SINGAPOREAN NOTICES TO MARINERS

The monthly Notices to Mariners contain information required to keep charts and publications published by the Hydrographic Division, Maritime and Port Authority of Singapore up-to-date.

CORRECTION NO.	SNM EDN NO.	LAST CORR N O.	CHART NO.	Location on Chart		
28 (sheet 2)	6/2020	19/2020	202		X

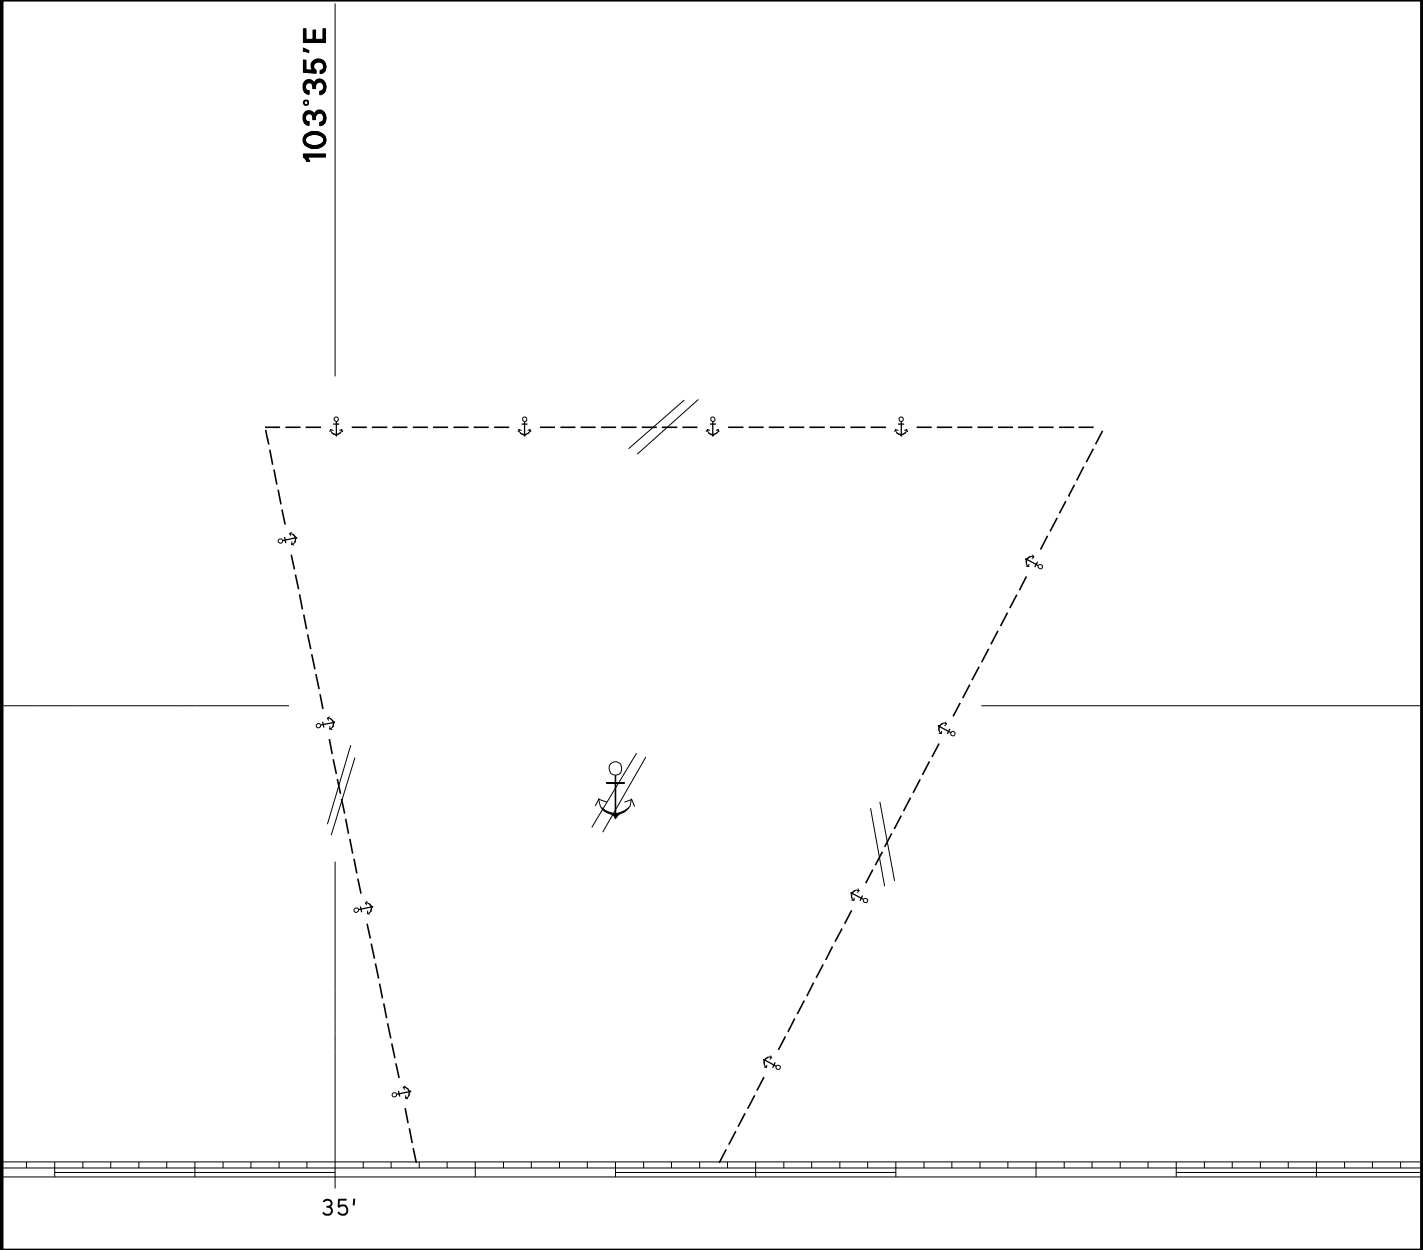
202	8 Ed 15/9/16 Last NM 19/2020 (Indonesia Notice no. 20/228/2020)		NM 28/2020
Delete	former limit of anchorage area, pecked line, joining:	0°56·60'N	104°22·10'E
		0°56·05'N	104°23·50'E
		0°55·37'N	104°23·26'E
		0°55·93'N	104°21·90'E
		and	
		1°05·15'N	104°11·26'E
		1°06·96'N	104°11·25'E
		1°06·96'N	104°10·00'E
		1°05·14'N	104°10·01'E
		and	
		1°11·00'N	104°09·00'E
		1°08·80'N	104°09·65'E
		1°08·80'N	104°10·67'E
		1°11·00'N	104°10·67'E
	legend,  Lay Up, centred on:	1°10·70'N	104°09·94'E
	former limit of anchorage area, pecked line and associated symbol, joining:	0°53·82'N	104°23·10'E
		0°52·99'N	104°23·69'E
		0°52·72'N	104°23·29'E
		0°53·56'N	104°22·72'E
		and	
		0°56·29'N	104°24·43'E
		0°56·29'N	104°24·88'E
		0°56·08'N	104°24·88'E
		0°56·08'N	104°24·43'E
		and	
		1°01·00'N	103°34·75'E
		1°01·00'N	103°37·75'E
		0°56·88'N	103°35·60'E
<hr/>			
501	7 Ed 1/9/15 Last NM 24/2020 (Indonesia Notice no. 20/228/2020)		NM 28/2020

CORRECTION NO.	SNM EDN NO.	LAST CORR N NO.	CHART NO.	Location on Chart		
				X

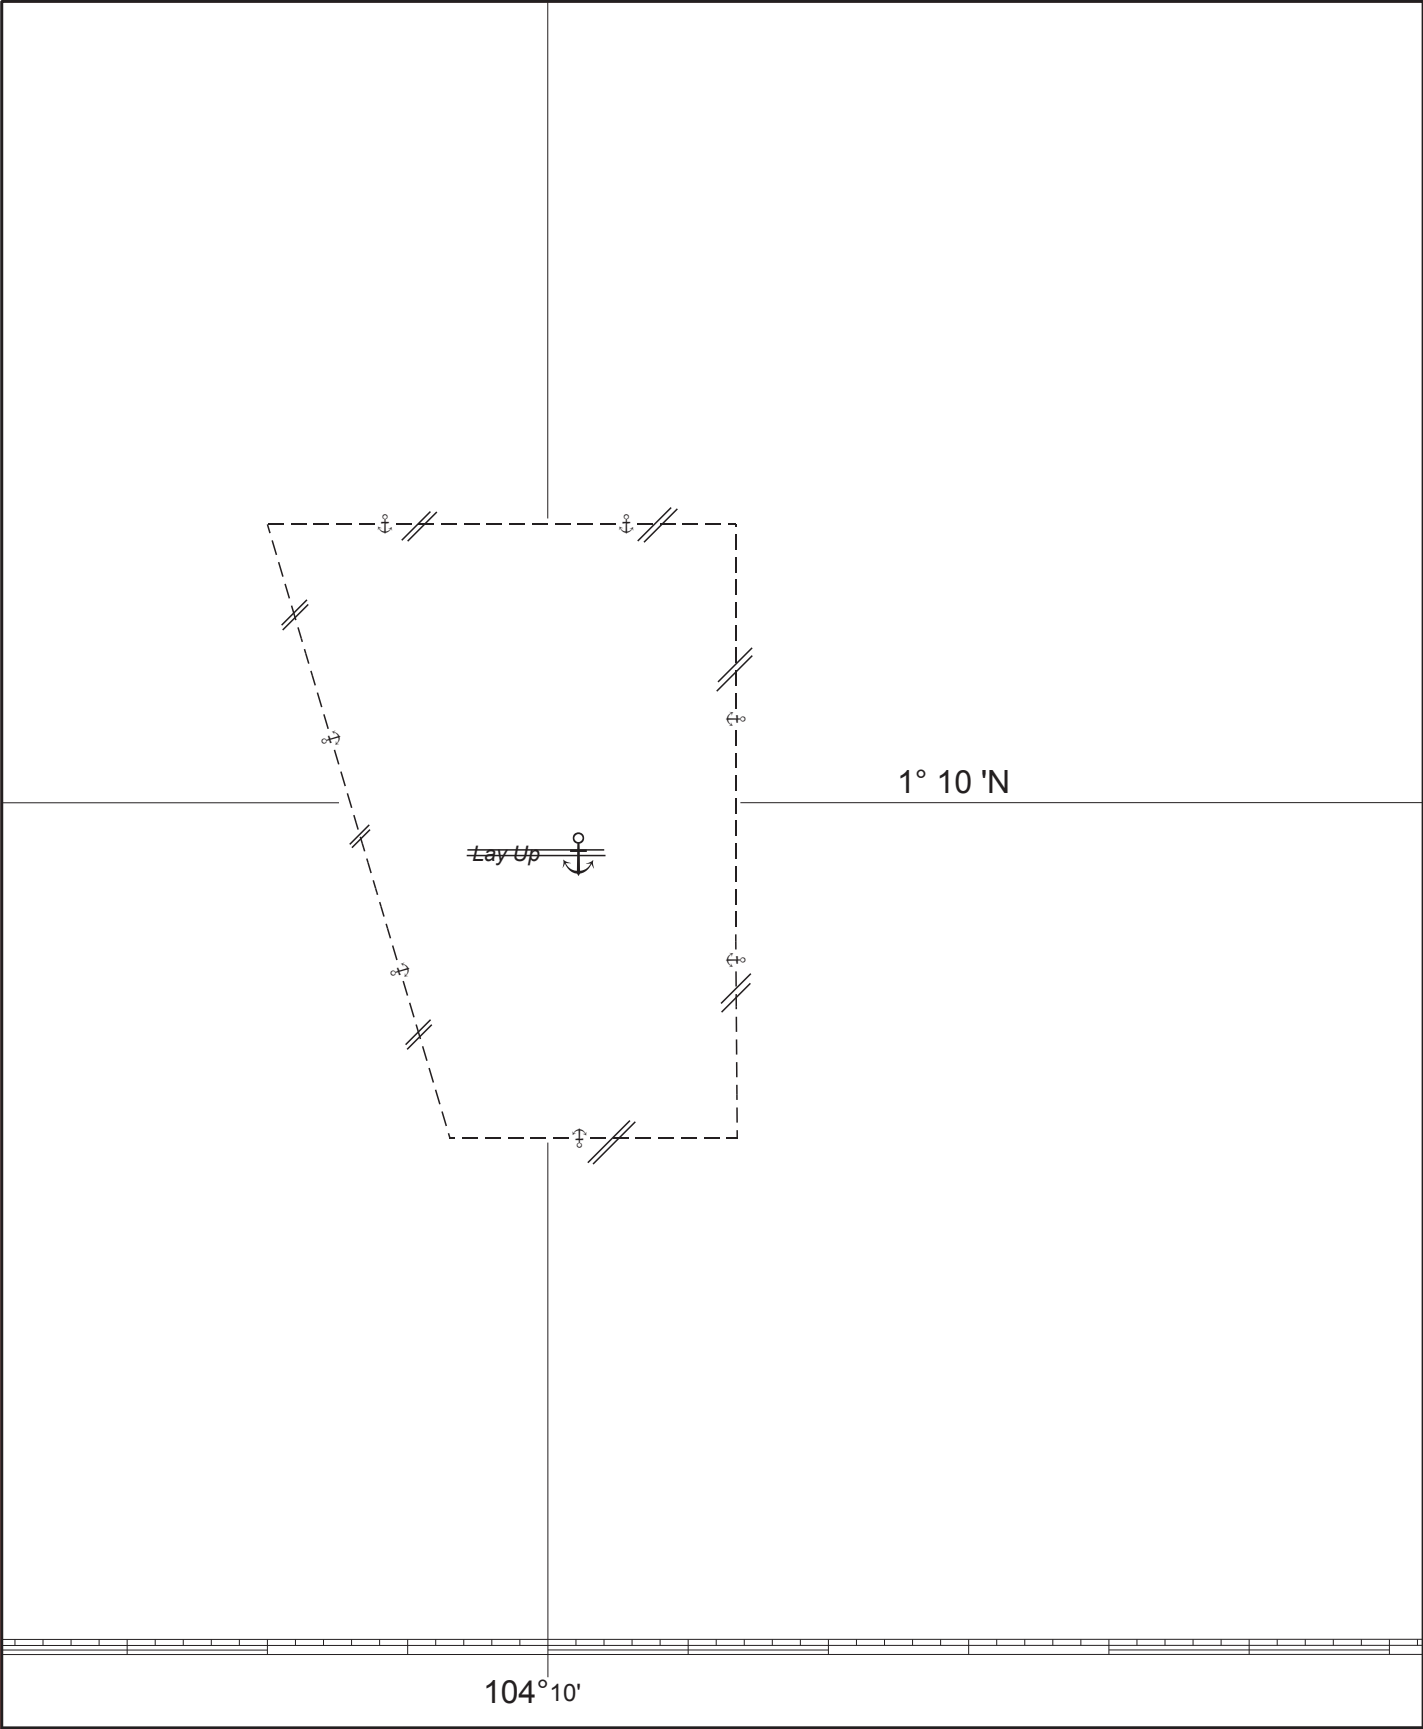
Delete	former limit of anchorage area, pecked line and associated symbol, joining:	0°58·36'N	103°35·29'E
		(chart border)	
		1°01·00'N	103°34·75'E
		1°01·00'N	103°37·75'E
		0°58·36'N	103°36·37'E
		(chart border)	
<hr/>			
502	8 Ed 12/9/19 Last NM 24/2020 (Indonesia Notice no. 20/228/2020)		NM 28/2020
Delete	former limit of anchorage area, pecked line and associated legend, joining:	1°11·00'N	104°09·00'E
		1°08·80'N	104°09·65'E
		1°08·80'N	104°10·67'E
		1°11·00'N	104°10·67'E
	legend,  Lay Up, centred on:	1°09·82'N	104°09·95'E
